January 19, 1973

Review of VAB System

- Based on: -- Operator's Manual for TECO-Harmison H.L. machine model #104 - Thermo Electron Corporation.
-- Screening report VAB system TR 102-1-T0.001. 1 September 1972. Utah BTL.
-- Conversations with Frank Altieri.

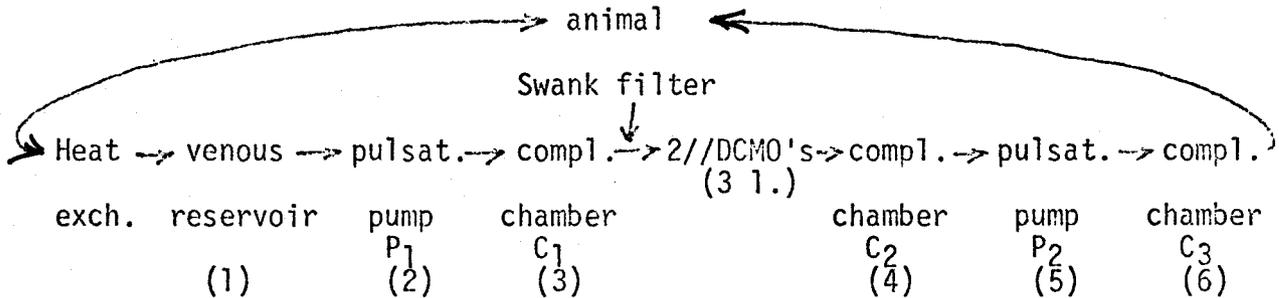
The pump design corresponds to the following schema:

It contains no less than six chambers through which the blood must circulate (not counting the heat exchanger and the DCMO's). These chambers are shaped in the form of cylindrical segments and are connected by means of much narrower circular conduits (Re - Operator's Manual figure IV-3). When circulated through the pump, the blood is therefore subjected to successive accelerations (in the conduits) and decelerations (in the chambers) with possible formation of jets and trauma to the constituents of the blood. The statement (UBTL p. 4-1), unsubstantiated by either data or references, that piston pumps may be gentler than rollers is difficult to understand in the light of this design.

The high input resistance (up to 125 mmHg) of the DCMO requires the use of a feeder pump. In the absence of comparative data related to the performance of the DCMO under pulsatile and linear flow both modalities were kept in pump P₁ rendering the system complicated. As will be seen later, continuous flow seems to be more suitable. Because the DCMO is a rigid non-compliant device, the pulsatile pump P₂ cannot accept a continuous flow from pump P₁, which renders the presence of compliance chamber C₂ mandatory.
